AGENDA ITEM EXECUTIVE SUMMARY					
	Title:		Plan Commission recommendation to approve a PUD Preliminary Plan for The Quad St. Charles – Cooper’s Hawk, Charlestowne Mall PUD, Unit 2, Lot 1.			
	Presenter:		Russell Colby			
Please check appropriate box:						
	Government Operations				Government Services	
X	Planning & Development (5/9/16)				City Council	
Estimated Cost:			Budgeted:	YES		NO
If NO, please explain how item will be funded:						
Executive Summary:						
<p>The subject property is Lot 1 of The Quad St. Charles, Unit 2, located at the northeast corner of Main St./Rt. 64 and the western entrance into the Charlestowne Mall site. The property is one of five outlot parcels created last year along the mall’s Main St. frontage. Krausz Companies (SC Outparcel One, LLC) is proposing to develop the lot with a Cooper’s Hawk Restaurant. Approval of a PUD Preliminary Plan is required to ensure compliance with the PUD ordinance and applicable provisions of the Zoning Ordinance.</p> <p>Plan Commission Review: The Plan Commission recommended approval of the PUD Preliminary Plan on 5/3/16, with a vote of 7-0, subject to resolution of staff comments. The Commission supported the building

4 **SOUTH ELEVATION**
3/32" = 1'-0"

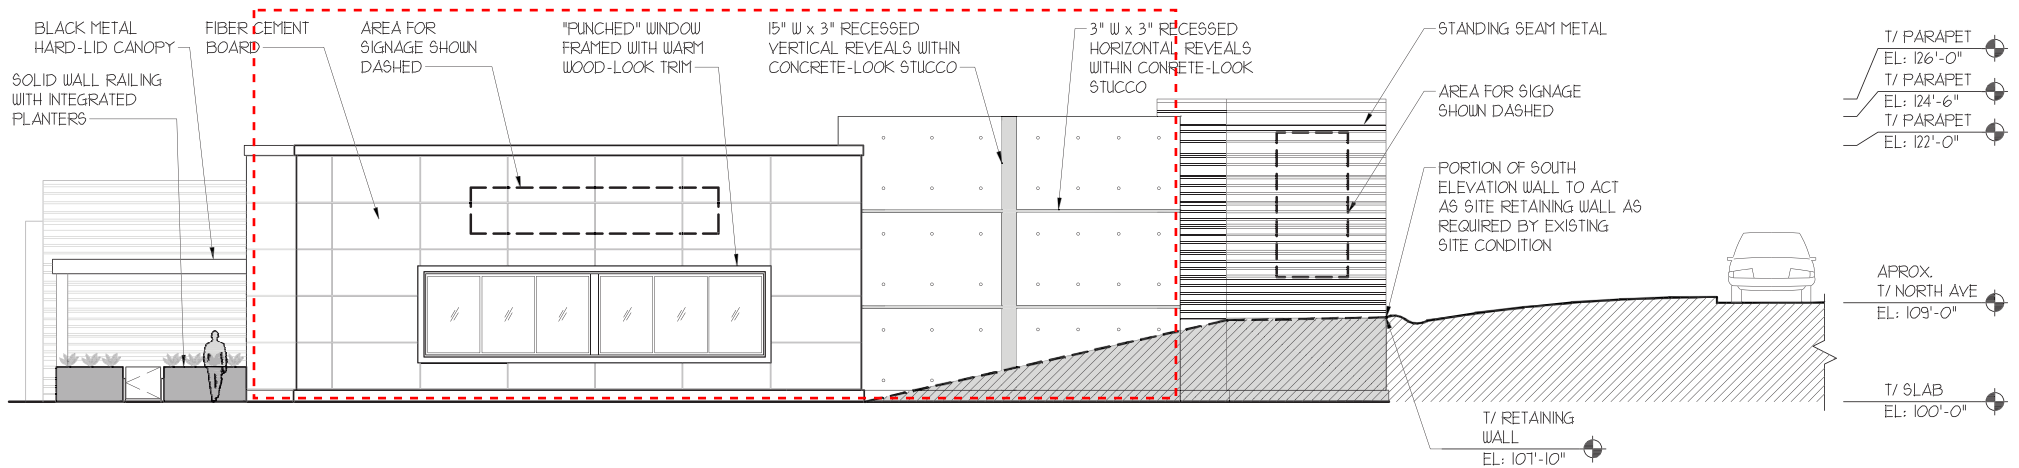
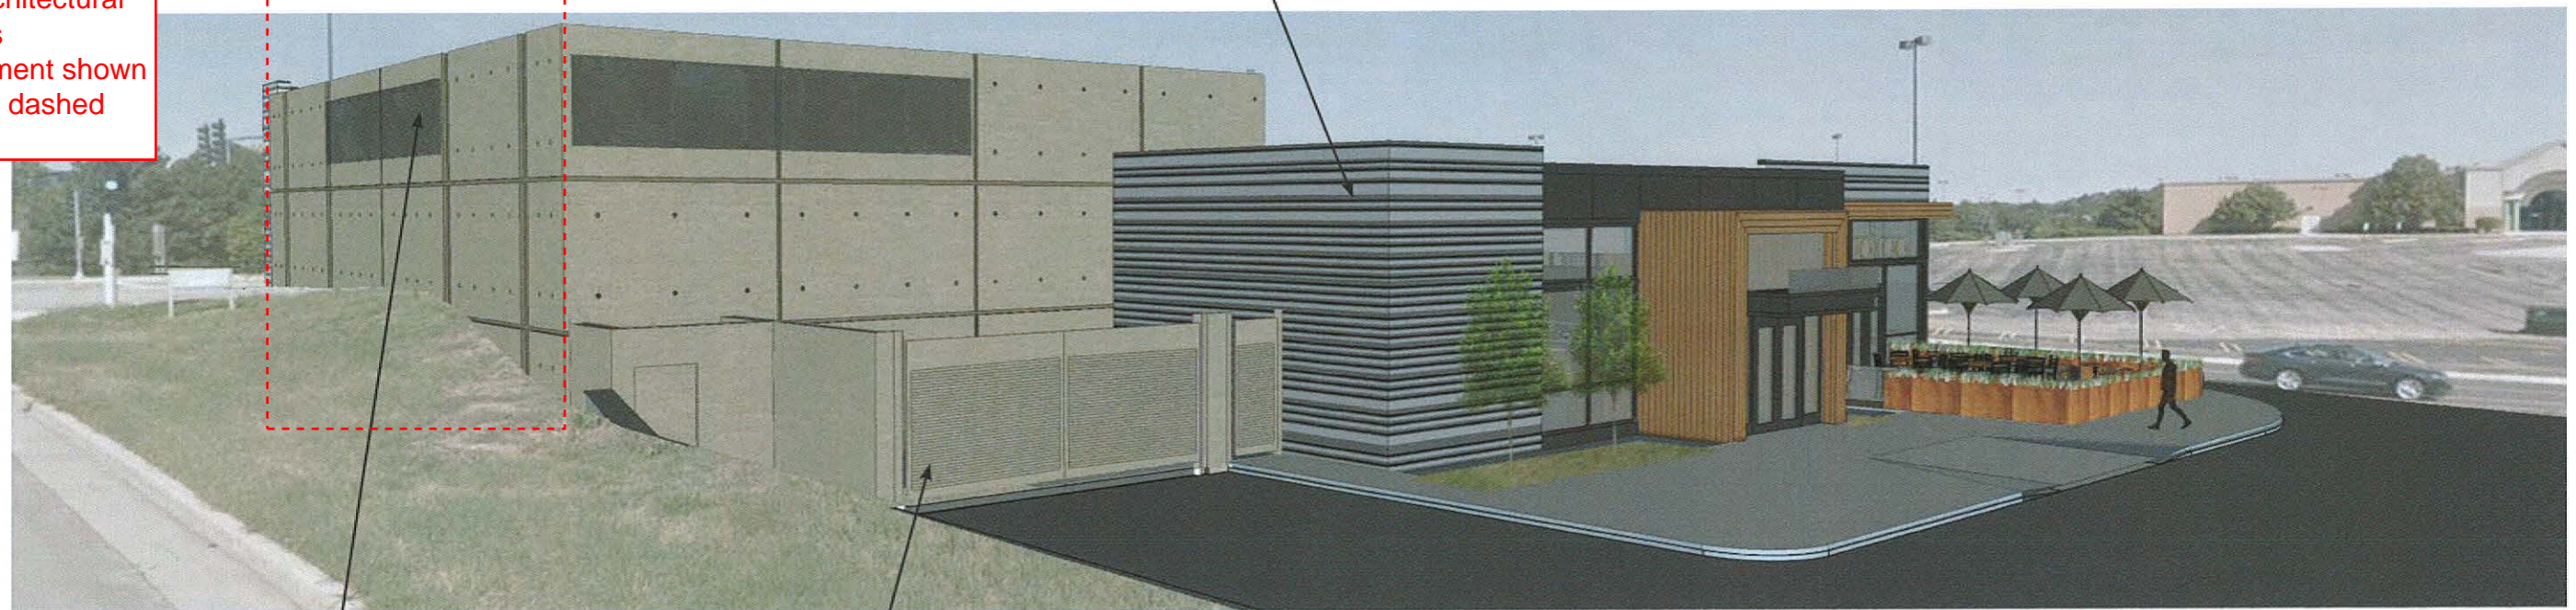
Staff is requesting the Planning & Development Committee provide an interpretation as to whether the south and west elevations of the Cooper's Hawk building comply with the code requirement for providing 50% architectural features.

Based on the calculation methods used in past practice, Staff calculate the percentage at 30%. The staff calculation was based upon adding up the square footage of all elements on the building wall that deviate from the base wall plane. This would include any banding or reveal lines, the signs, and the cornice and window on the west elevation. The staff calculation does not account for the varied building shape/footprint, the use of multiple contrasting building materials around the building, or the use of a textured pattern across some sections of wall.

- Additional architectural features must be added on the south and west facades.

Wall section deficient in 50%
architectural feature
requirement shown in red
dashed outline
